**Request for Reconsideration:**

Appl'n No. 10/053,582  
Amd't Dated Feb. 1, 2005  
Reply to Office Action of Dec. 9, 2004  
Annotated Sheet Showing Changes

**Fig. 3**

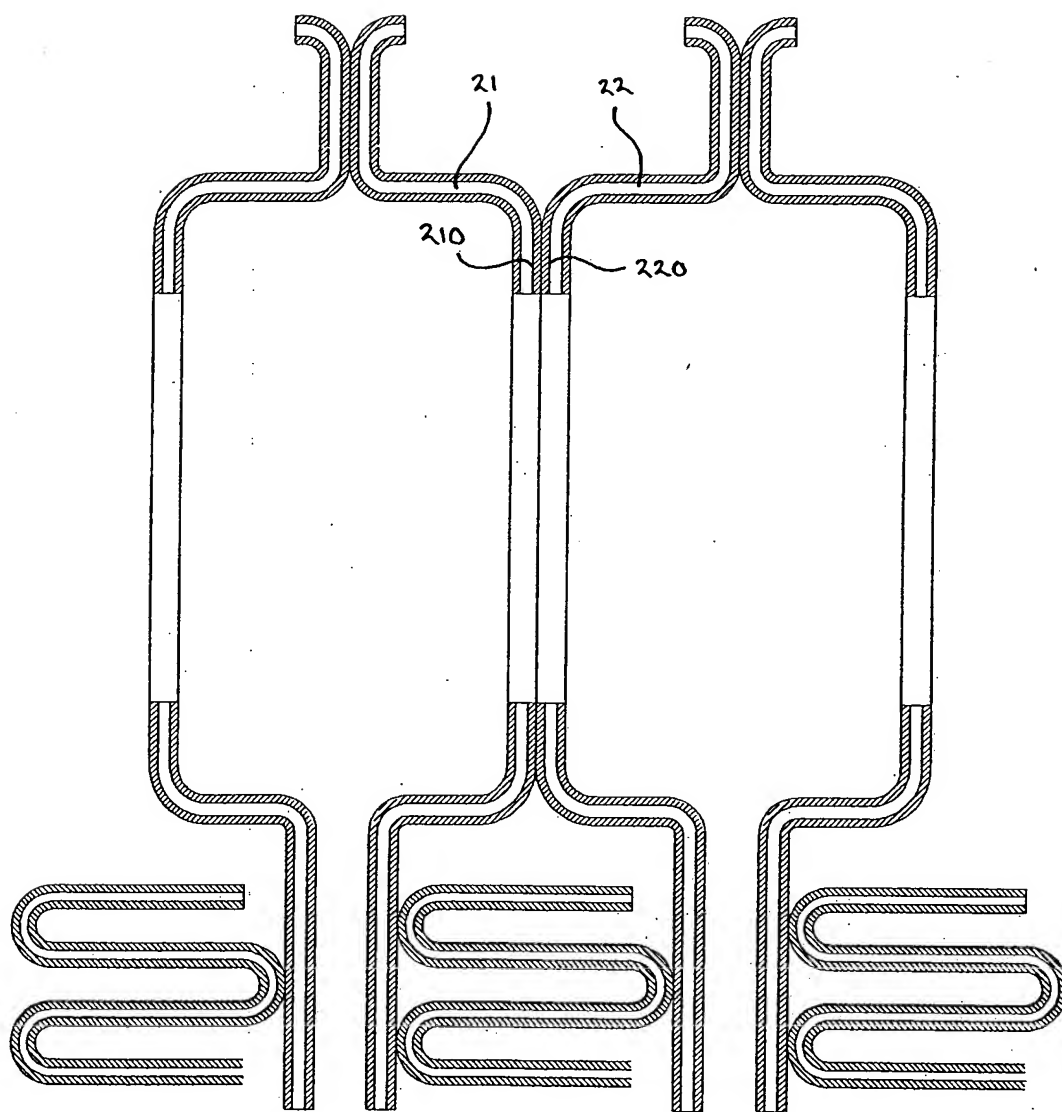
The attached sheet of drawings rennumbers **Fig. 2**, which was submitted in the Responsive Amendment filed August 10, 2004, as **Fig. 3**. This sheet, which includes renumbered **Fig. 3**, replaces the original sheet including **Fig. 2**.

← RENUMBER  
FIG. 2 SUBMITTED  
08/10/04, AS FIG. 3
